Sanitary Sewer to Serve WICHITA DESTINATION DEVELOPMENT - PHASE 2 LOT 2 & 3, K-96 GREENWICH ADDITION

SANITARY SEWER PLANS
RIC PROJECT NO. 14-0225
GOODSPORTS INFRASTRUCTURE

AS BUILTS

SANITARY SEWER PLANS

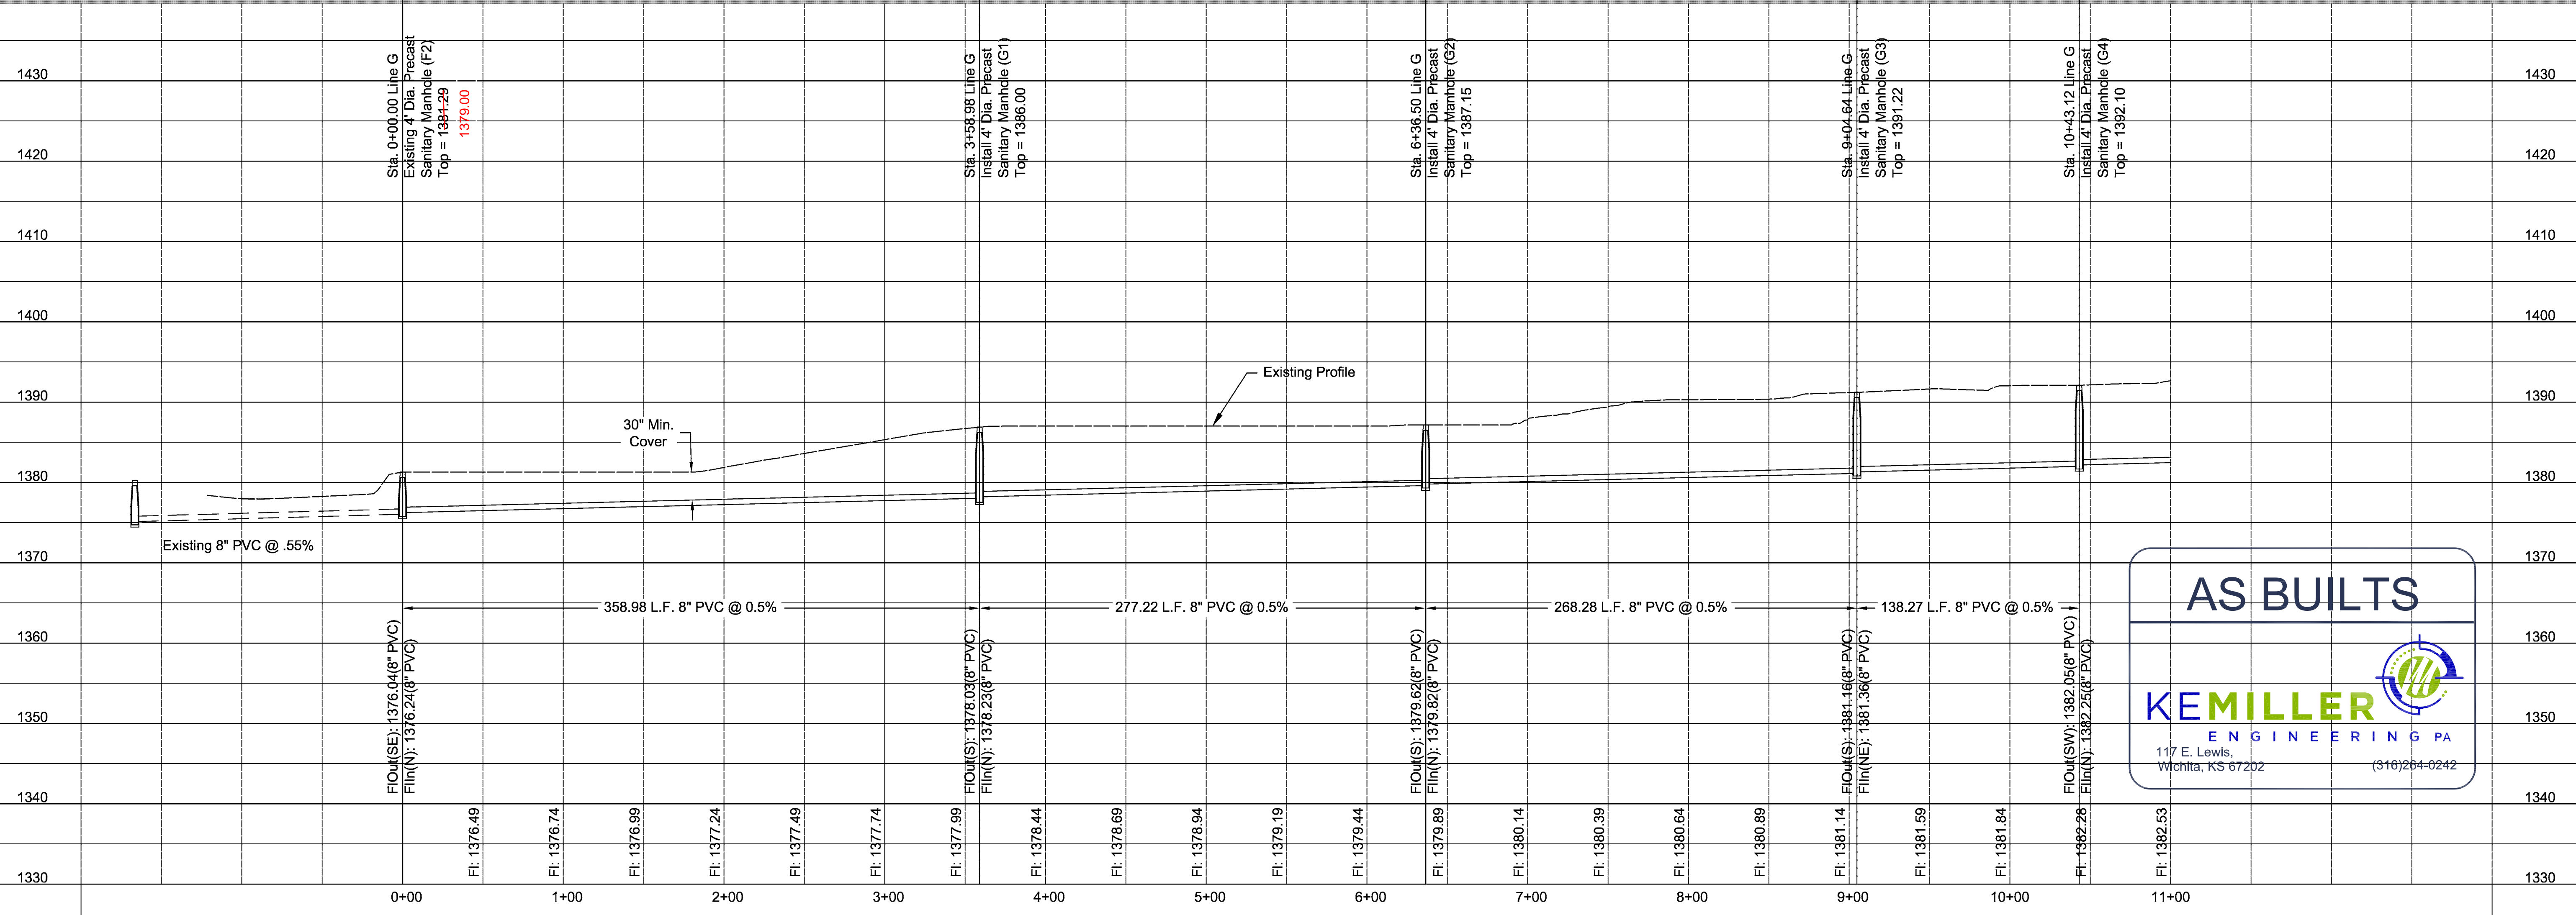
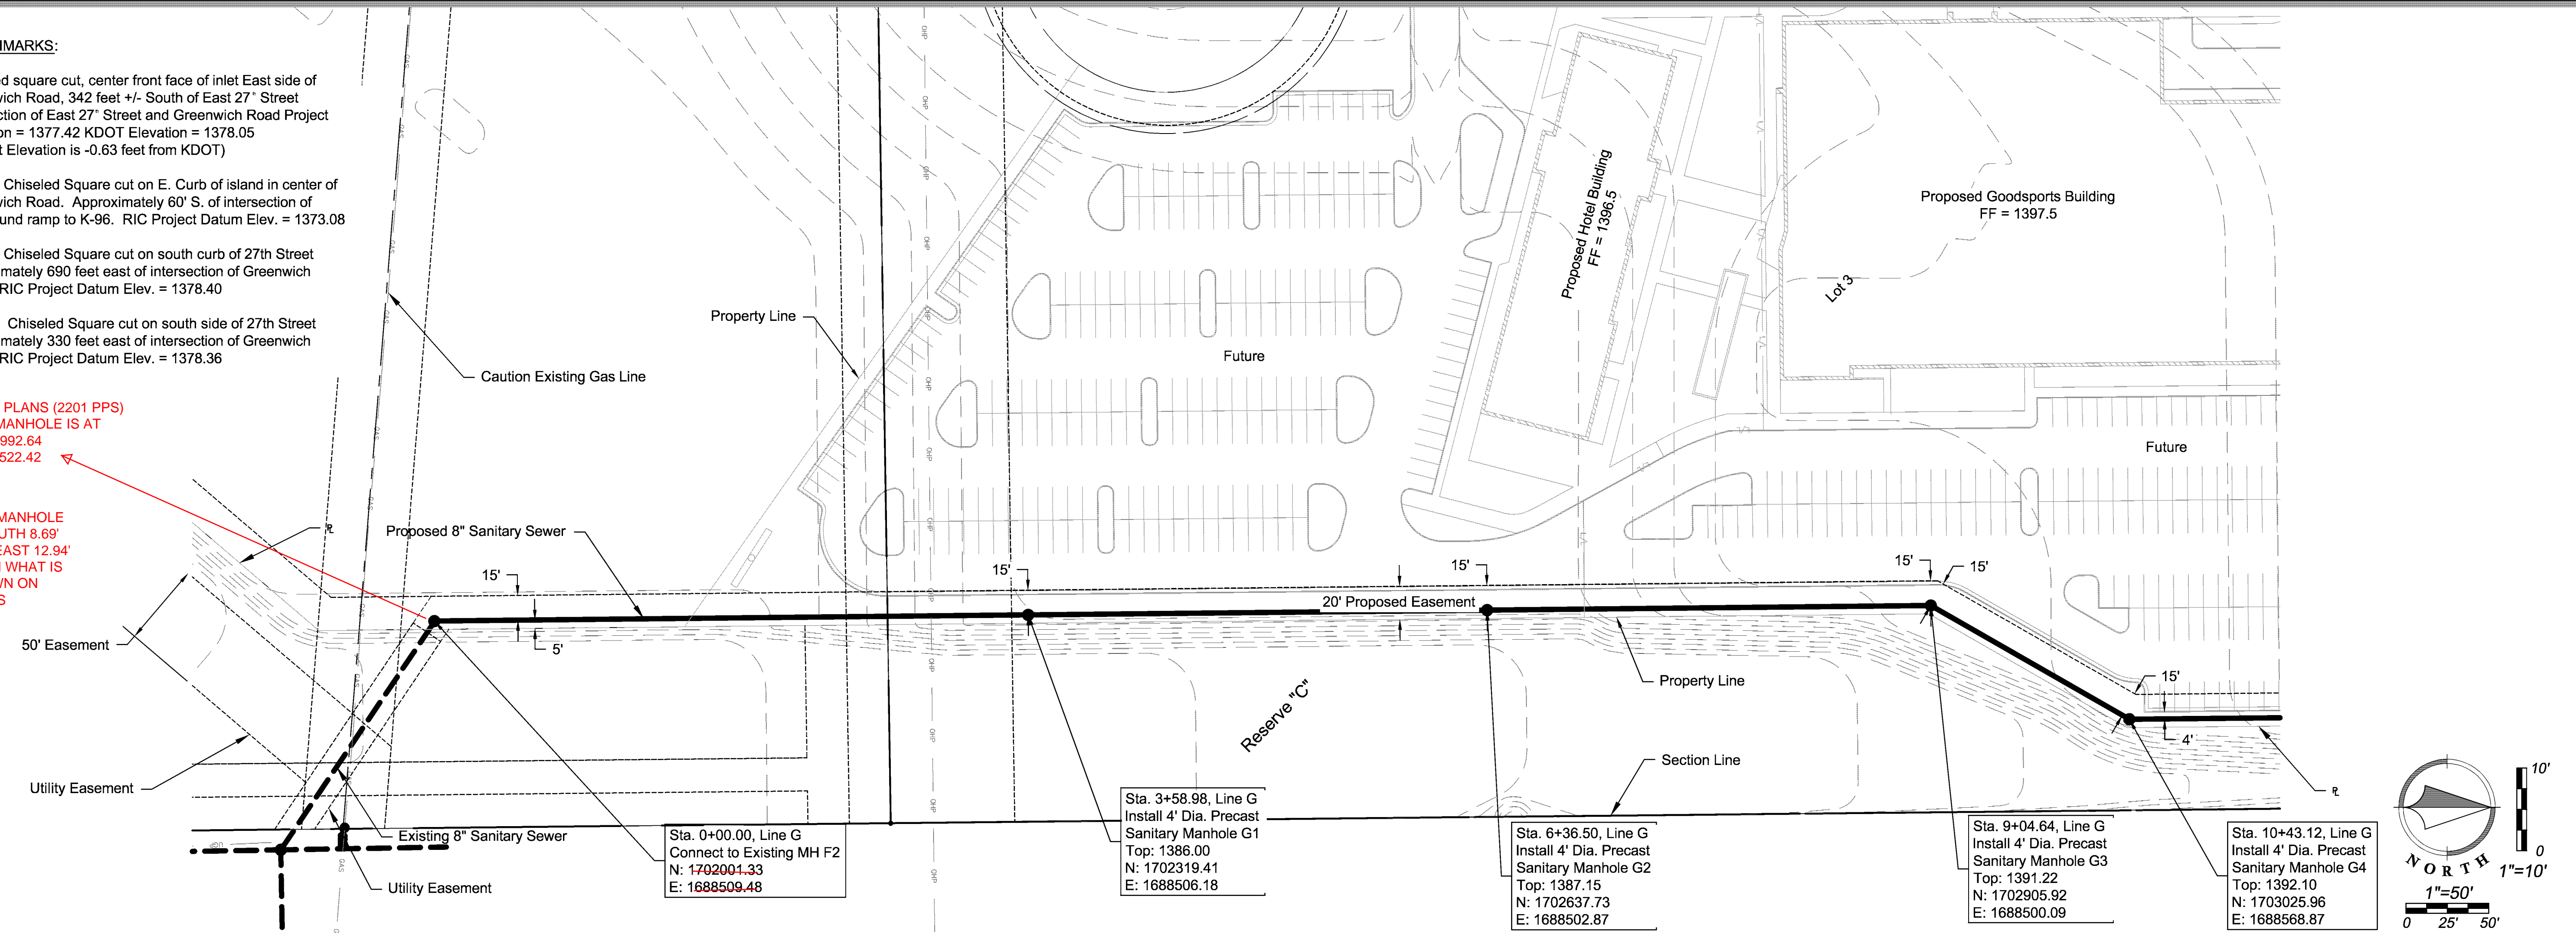
FROM PLANS (2201 PPS)
THIS MANHOLE IS AT
N1701992.64
E1688522.42

THIS MANHOLE
IS SOUTH 8.69'
AND EAST 12.94'
FROM WHAT IS
SHOWN ON
PLANS
